ADDENDUM NO. 1

PN15210009 & 15210012 Kalaeloa Building 1874 & Building 1898
Construction of Two Stand-by Emergency Generators, Kalaeloa, Oahu, State
of Hawai'i, Department of Defense,
Hawaii Army National Guard, Job No. CA-202004-C6

- A. KALAELOA (BUILDING 1874) CONSTRUCTION OF STAND-BY EMERGENCY GENERATOR INSTALLATIONS DRAWINGS (7 SHEETS, E001, E101, E102, E103, E104, E201, E202)
- B. KALAELOA (BUILDING 1898) CONSTRUCTION OF STAND-BY EMERGENCY GENERATOR INSTALLATIONS DRAWING(4 SHEETS, E101,E201,E203,E402,)

E104

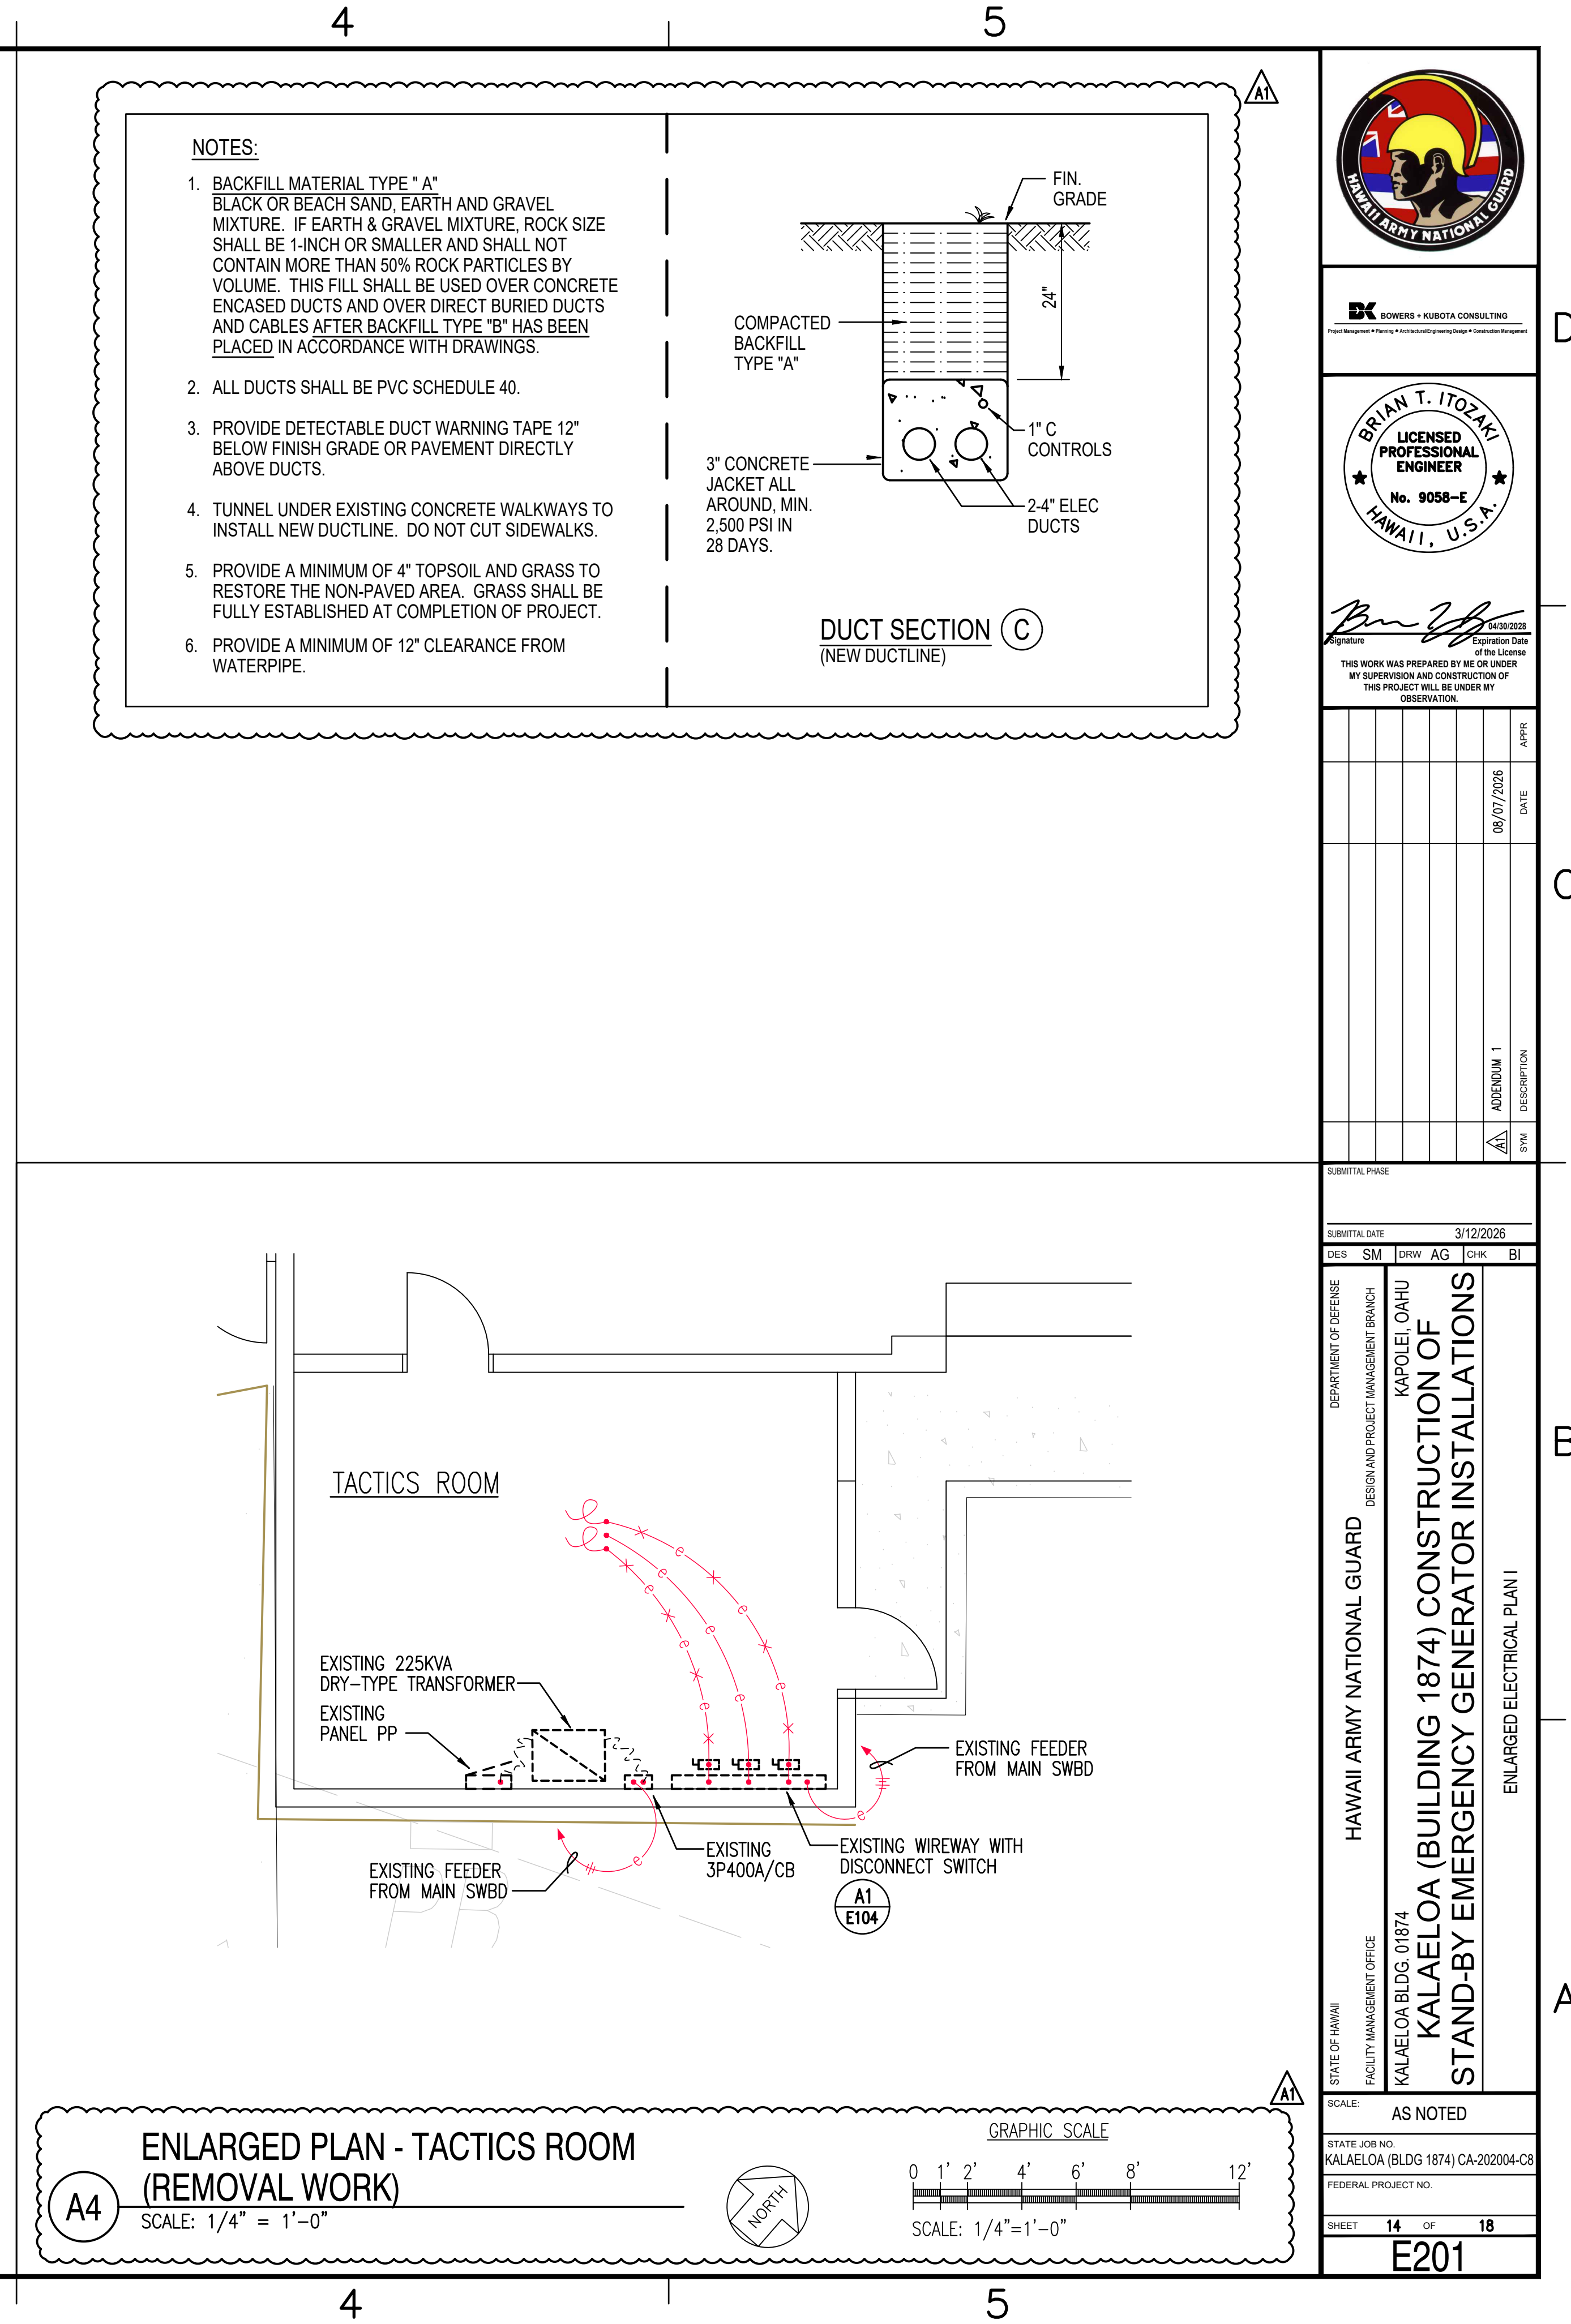
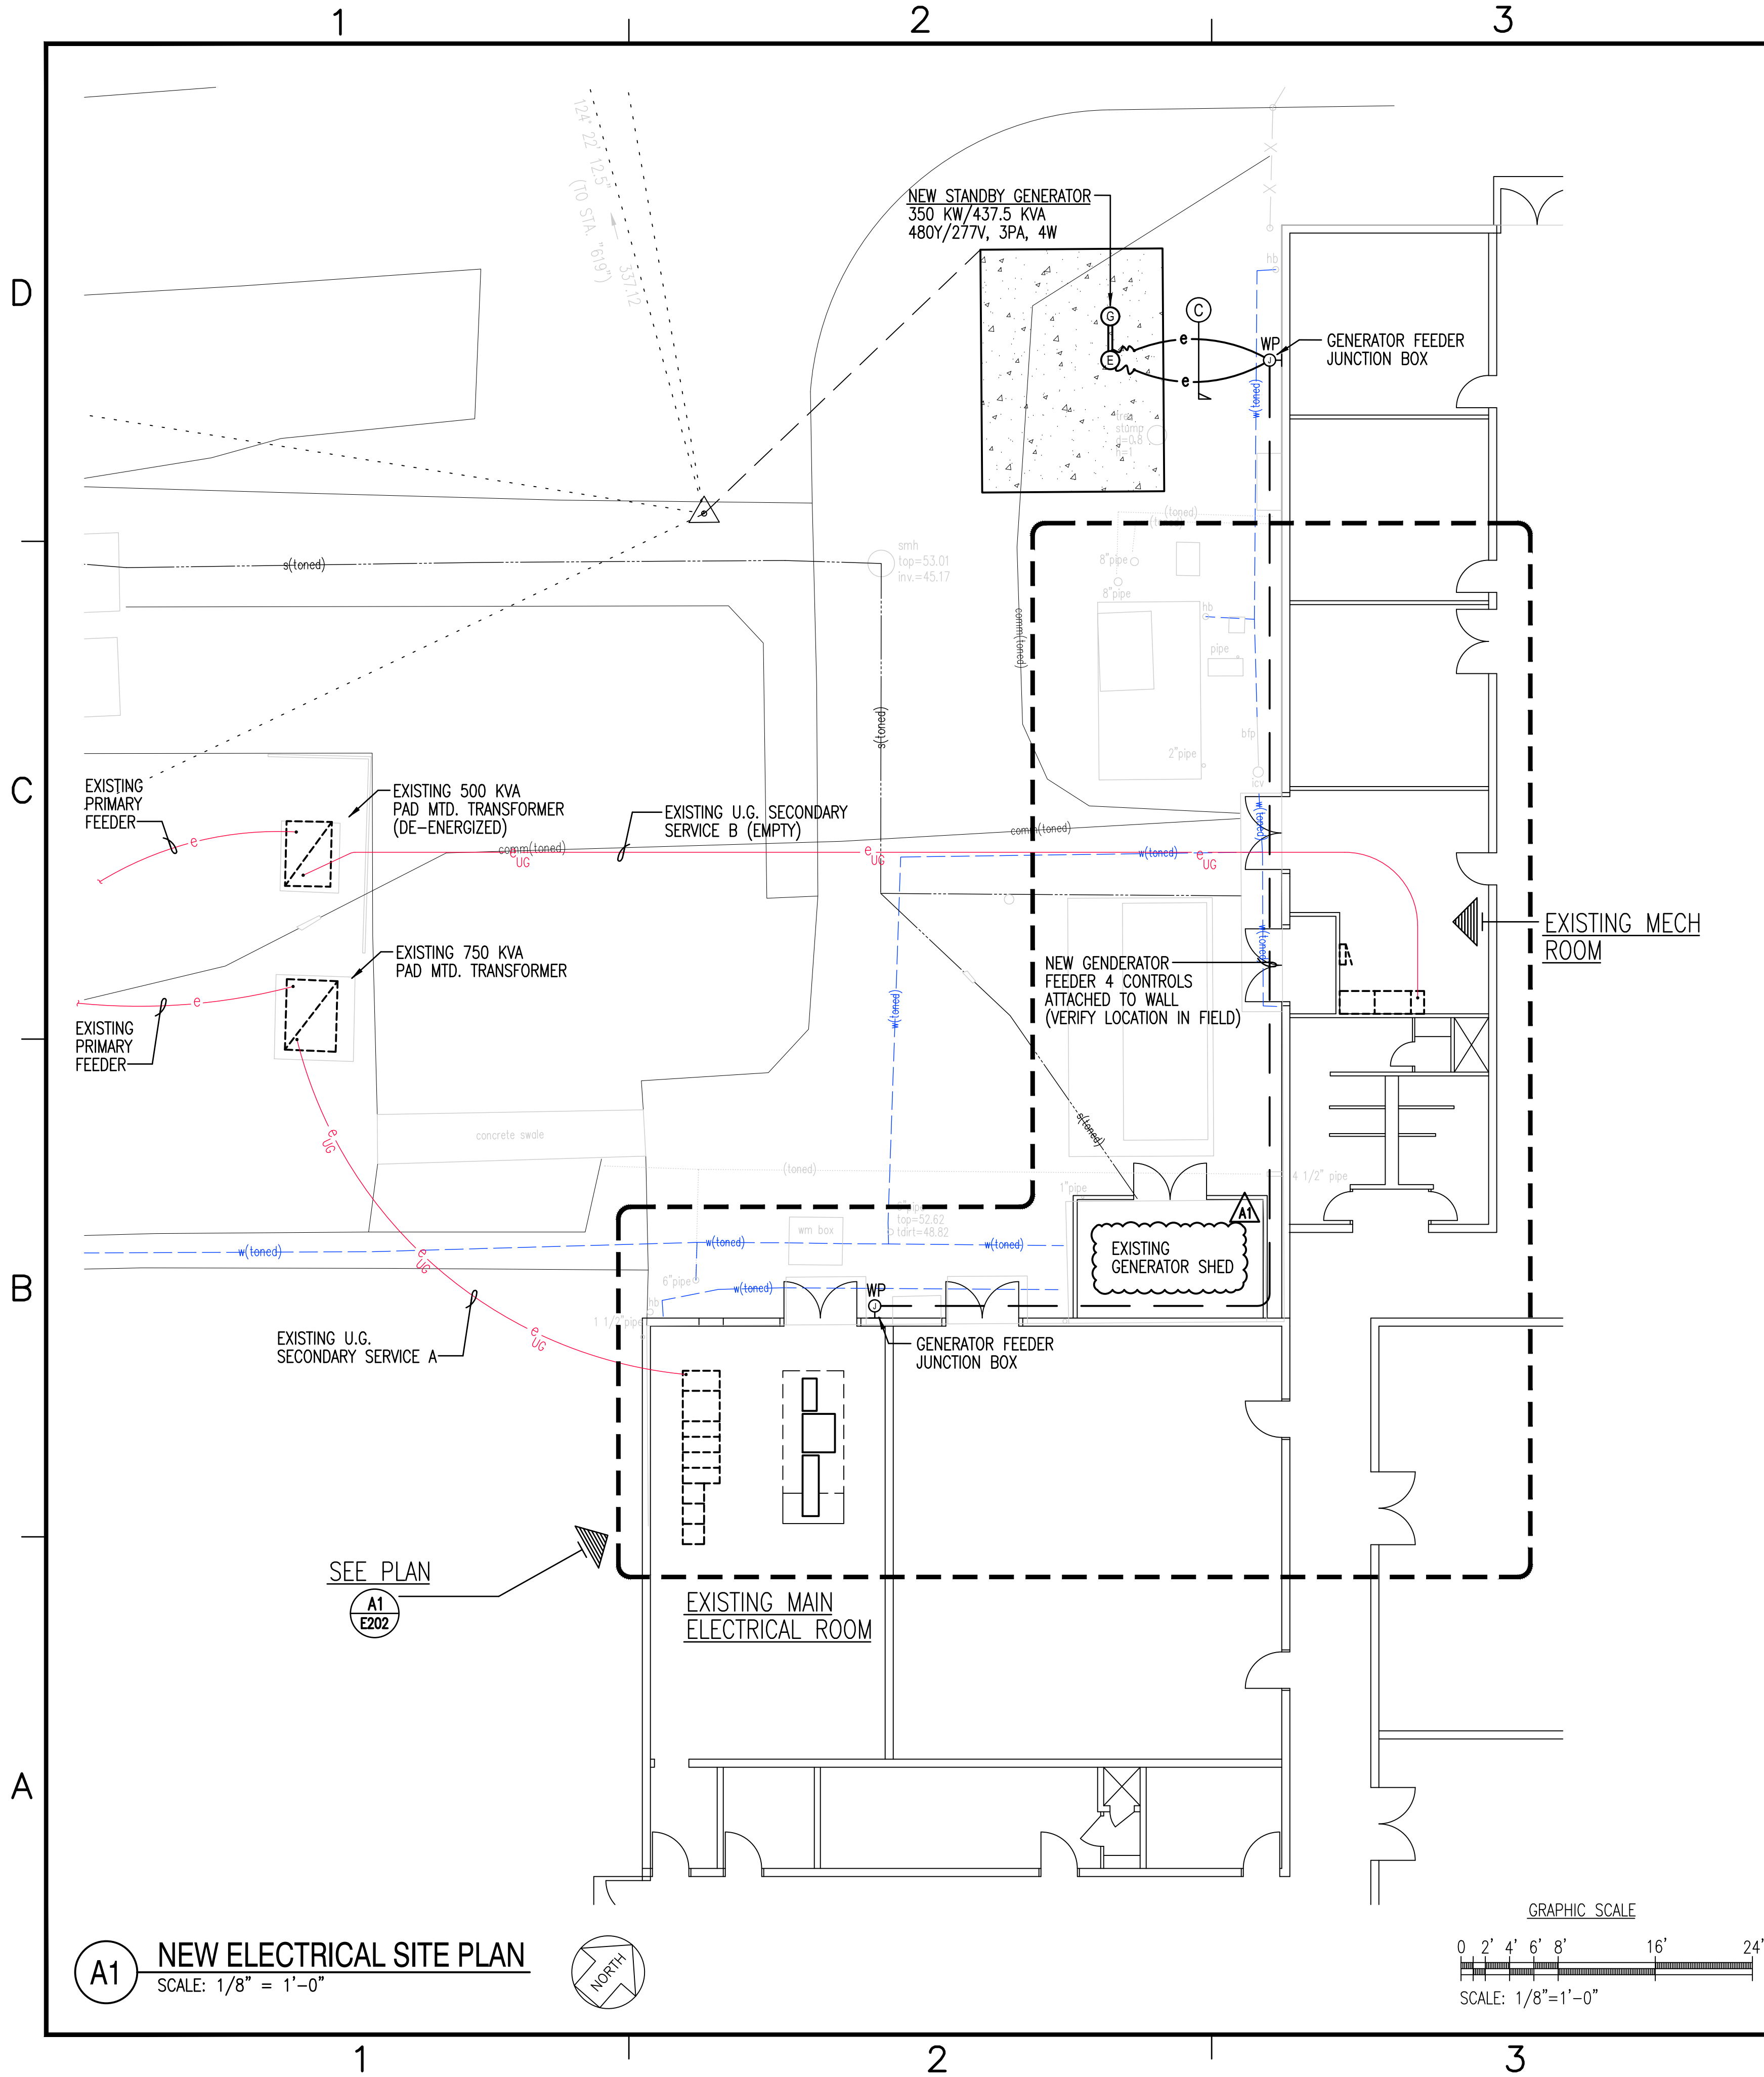
2. On sheet E-104 Note 3 calls for de-energizing the existing transformer. Is the intent to disconnect the medium voltage splice in the manhole or turn off the secondary at the transformer.

A. The de-energizing of the existing transformers will be performed by the respective utility companies. The Contractor will arrange for the work with the utility companies.
